テクニカルノート

TECHNICAL NOTES
ON
PREPARATORY SURVEY ON THE PROJECT
FOR EXPANSION OF WATER SUPPLY SYSTEM
IN PURSAT AND SVAY RIENG
IN THE KINGDOM OF CAMBODIA

TECHNICAL NOTES
ON
THE PREPARATORY SURVEY ON THE PROJECT
FOR EXPANSION OF WATER SUPPLY SYSTEM
IN PURSAT AND SVAY RIENG
IN THE KINGDOM OF CAMBODIA

Figure A1-1 Candidate Intake Sites along the Pursat River

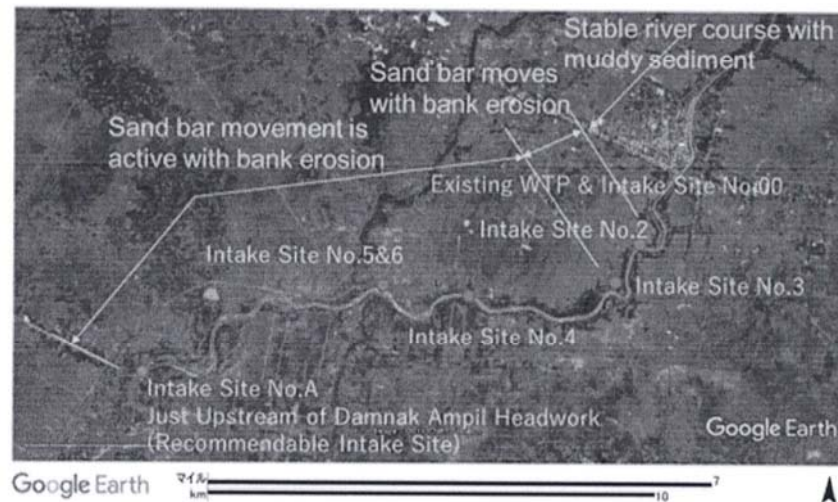
Considering the conditions of stability of the river channel, movement of sand bars with bank erosion as well as problems of inflowing muddy sediment into the pump of the existing intake facility, as a result of comparing and examining seven water intake candidate sites (see **Annex-1**), the Team recommended withdrawing from the immediate upstream of Dhamnak Ampil Headwork (Site No.A) as the best option.

The recommended second option is intake from the immediate upstream of the existing intake point (Site No.00).

Figure A2-1 Candidate Intake Sites in the Vay Kor Lake

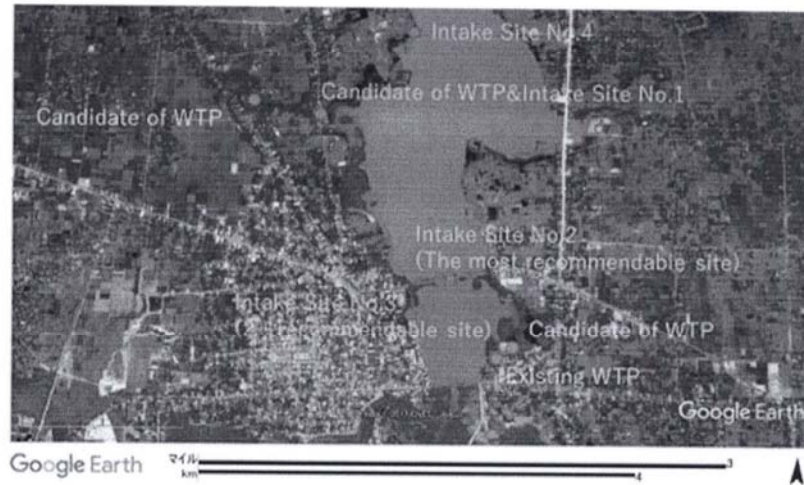
The Team compared the candidate intake sites in the Vay Kor Lake (see **Annex-2**). As per the results, the most recommendable intake site is at the north side of the road dike of National Road No.1 (NR1)

besides the existing bridge in the Vay Kor Lake (Site No.2). This is because, the water surface is near the road dike of NR1 and enough water depth during the dry season can be obtained under proper management of surface water resources of the Lake.

Figure A4-1 Candidate Site for New WTP in Pursat

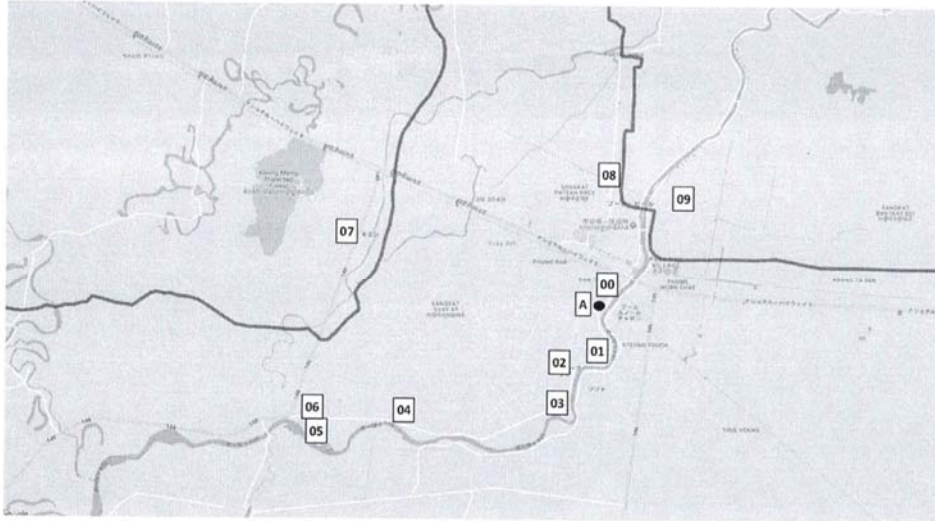
To select the site of a new water treatment plant in Pursat, the Team made a preliminary evaluation for eleven candidate sites, proposed by the Cambodian Side (refer to **Figure A4-1**).

As a result of discussion among the MIH, Pursat provincial waterworks and the Team, three sites (No.04, 05 and 06) were selected as candidate locations.

The reason for selection of No.04, 05 and 06, is to be located at the middle points between the potential water source (Dhannak Ampil Headwork) and the water supply area including future expansion supply area. In addition, these sites are more adequate locations than the others to distribute water to the supply area efficiently.

Figure A4-2 Candidate Site for New WTP in Svay Rieng

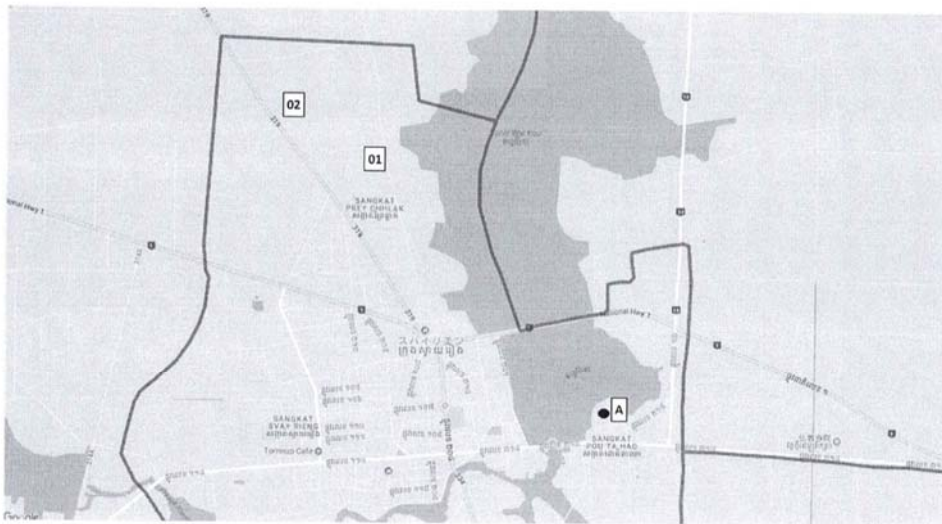
To select the site for a new water treatment plant in Svay Rieng, the Team made a preliminary evaluation for three candidate sites, proposed by the Cambodian Side (refer to **Figure A4-2**).

As a result of discussion among the MIH, Svay Rieng provincial waterworks and the Team, one site (No.02) was selected as a candidate location for new water treatment plant.

The reason of selection for No.02 is that it is to be located at the point relatively close to the proposed intake location and the water supply area including future expansion supply area. In addition, this site is an adequate location to distribute water to the supply area efficiently.

Annex-2 Intake Facility

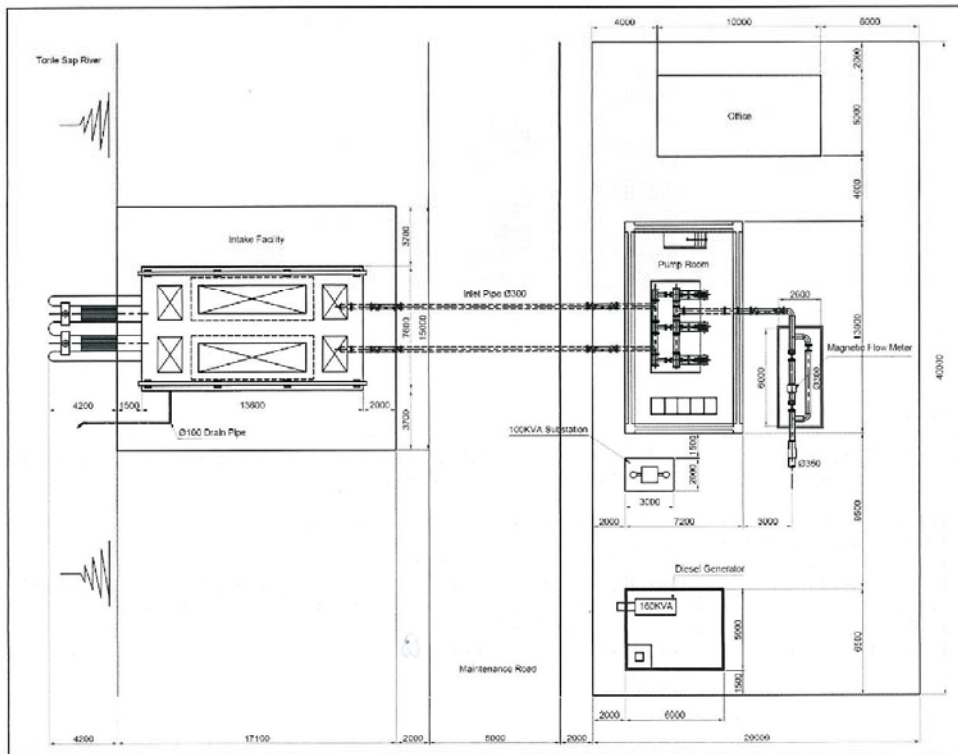
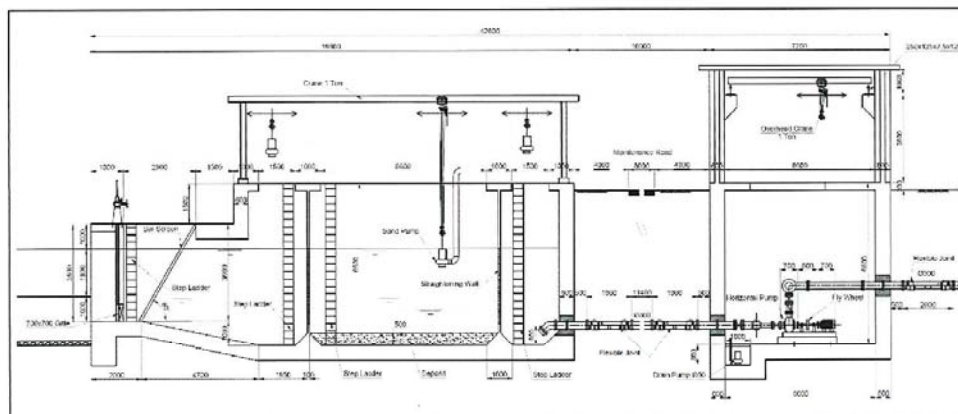
With reference to the method of abstracting water from Pursat River, the Team explained two alternative methods such as open channel type (see **Figure A2-1** in **Annex-2**) and horizontal suction pipe with strainer which is the same water intake method as the existing facility. MIH agreed to adopt the open channel type because it is easy to clean out the sediment in the intake passage. The outline specification for intake facility is shown in **Table A2-1** in **Annex-2**.

Sluice gates shall be installed at the intake mouth of channel for stoppage of flowing water. Grit chambers were recommended to be constructed in front of the pump suction pit to remove sand. To protect from erosion, appropriate bank protection shall be constructed at extend of 20m length to upstream and downstream.

Figure A3-1 Candidate Site of New WTP

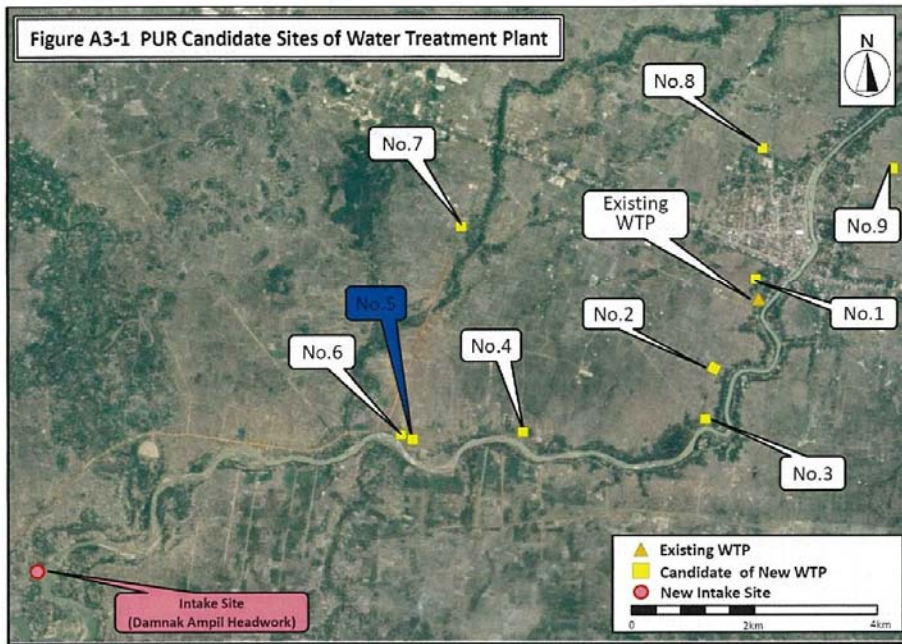
To select the site of a new WTP, the Team made a preliminary evaluation for eleven candidate sites, proposed by the Cambodian Side (MIH, Pursat DIH and Pursat Waterworks) (refer to **Figure A3-1** in **Annex-3**).

Figure A3-2 Location of New WTP

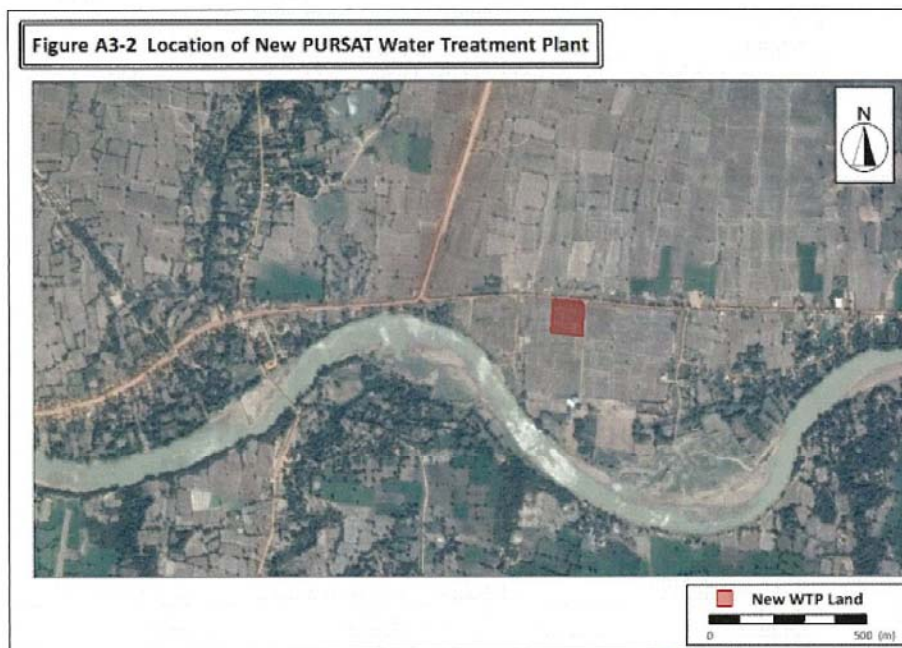
As a result of discussion among MIH, Pursat provincial waterworks and the Team, one site (Site No.5) was selected as candidate location (refer to **Figure A3-2** in **Annex-3**).

The reason of selection for Site No.5 is to be located at the middle points between the potential water source (Dhamnak Ampil Headwork) and the water supply area including future expansion supply area. In addition, this site is most adequate than the others to distribute water to the supply area efficiently.

Figure A3-3 Layout of New WTP (one of the alternative layouts) ③

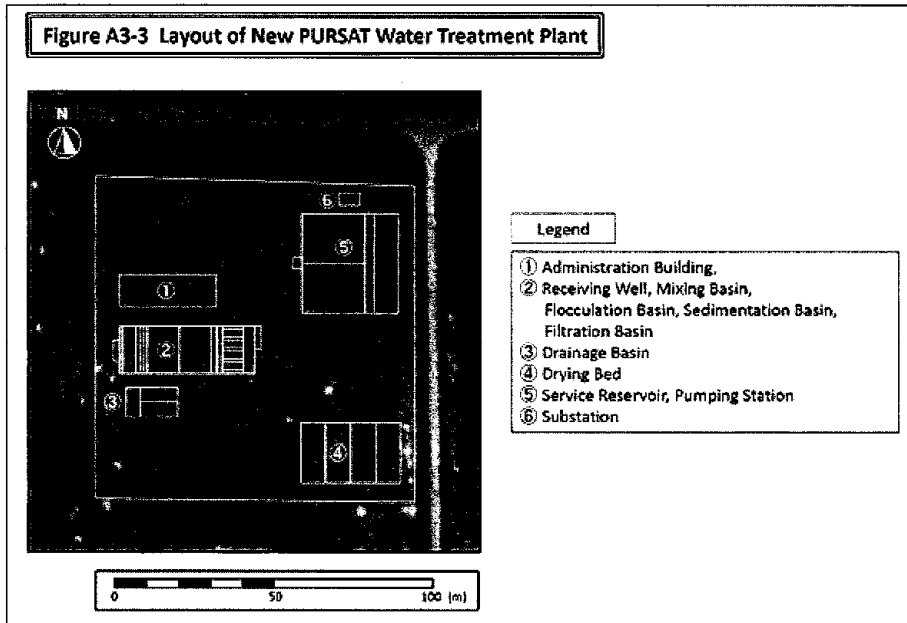
And MIH, Pursat provincial waterworks and the Team discussed the layout and design condition of new WTP which needs further discussion for finalization. (refer to **Figure A3-3** and **Table A3-1** in **Annex-3**).

MIH requested to the Team more detail information about comparison of the alternative WTP layouts. The Team agreed to provide more detail information and continuous discussion with MIH.

Figure A8-2 Sketch of the Structure of Vay Kor Dam (based on the Information from DOWRAM Svay Rieng Province)

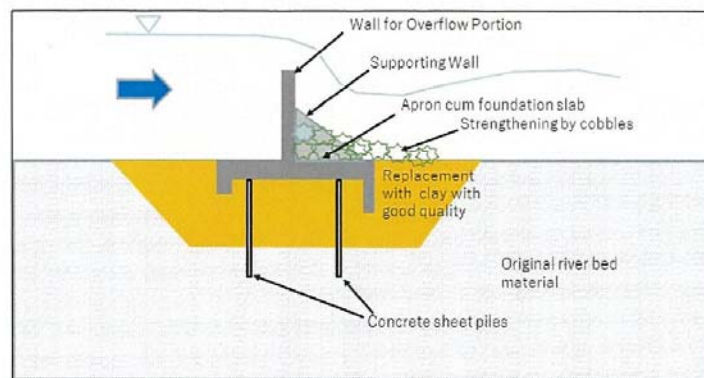
The Team explained the following problems of Vay Kor Dam. By these problems, it is not possible to secure long-term safety of taking raw water from the Vay Kor Lake. Photos and sketch of Vay Kor Dam structure are shown in **Annex-8**.

There is a possibility of causing damage to Vay Kor Dam or possibility of collapsing the Dam (even partially) due to recurrence of scouring at the foundation portion of the Dam. If the Dam is damaged, water in Vay Kor Dam will flow out, and the reservoir will be empty.

There is a possibility of causing damage to the structure of Vay Kor Dam or possibility of partial collapsing of the Dam due to deterioration of the supporting walls and concrete walls of the Dam.

Vay Kor Dam cannot secure the stability against sliding and overturning with or without of riprap in the downstream side as counterweight. If the Dam is collapsed (even partially), water will flow out from the Lake.

Flood safety level of Vay Kor Dam is low with only 5 to 10-year return period of floods due to insufficient discharge capacity of the overflow portion of the Dam. Normally, the flood safety level of this kind of Dam (weir) should be more than 50-year return period of flood.

Figure 1 Illustration of DMA (Distributed Metered Area)

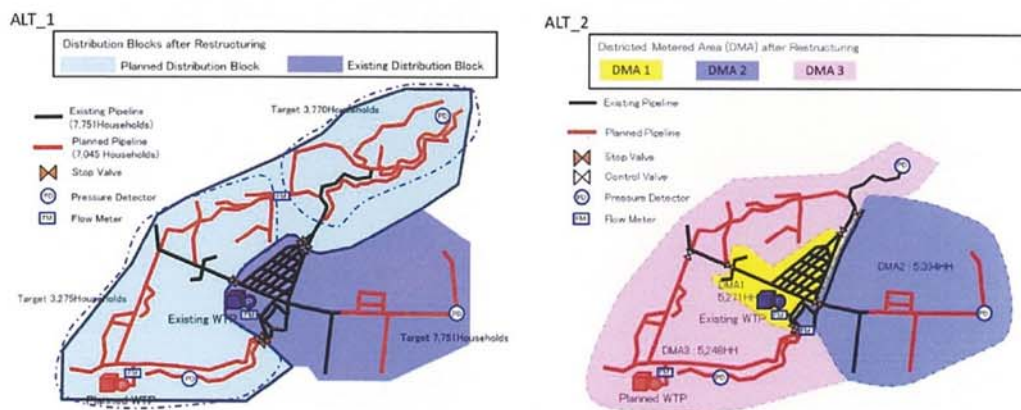
- 1) Some villages in northern area of coverage area on original design are excluded from proposed coverage area and some distribution pipes from coverage area on original design are removed.
- 2) The existing coverage area shall be divided and classified into separate DMAs. The scale of DMA including existing water treatment plant shall be set in accordance with the capacity of existing water treatment plant. The other new DMA will enhance the distribution capacity of the existing coverage area by combining the part of the existing coverage area and new coverage area as the new DMA.
- 3) Based on the above, revised figure of DMA is shown as “ATL_2” in **Figure 1**.

Figure A1-1 General Drawing of Intake Facility

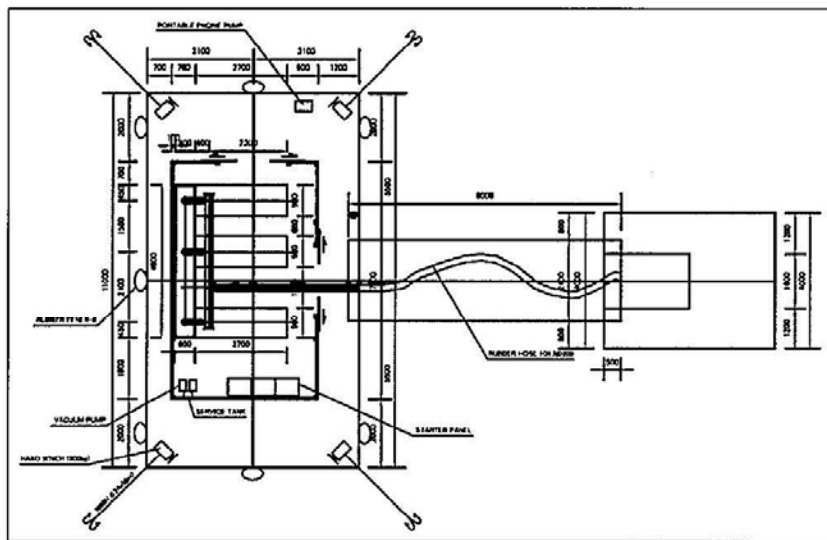
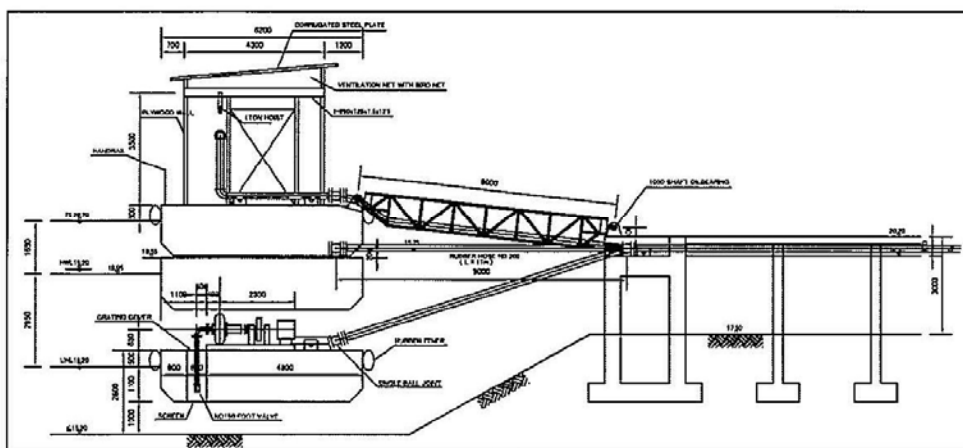
The Team explained that it is better to adopt pontoon type intake facility because of easier maintenance and less electric cost than rail type intake facility. MIH agreed to adopt pontoon type intake facility whose drawing and specification shown in **Figure A1-1** and **Table A1-1**. The maintenance items for pontoon type intake facility are (1) cleaning of flown litter, branches and leaves etc. around the pontoon, (2) periodical painting for rust prevention and (3) maintenance of the parts of intake pump such as impeller, shaft and bearing etc.

Figure A1-2 General Drawing (sample) of Sand Basin (elevated type)

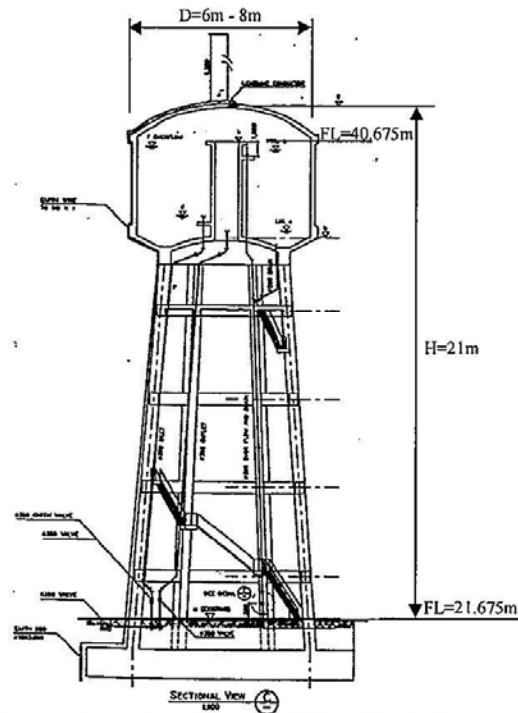
With reference to the method of settling the sedimentation at the intake site, the Team explained to provide sand basin (elevated type) instead of ground type sand basin on the original design. The MIH and Team agreed to adopt sand basin (elevated type) at the land side of intake facility site instead of ground type sand basin considering the cost estimation result and affordability of budget to provide the sand basin (elevated type) shown in sample **Figure A1-2**.
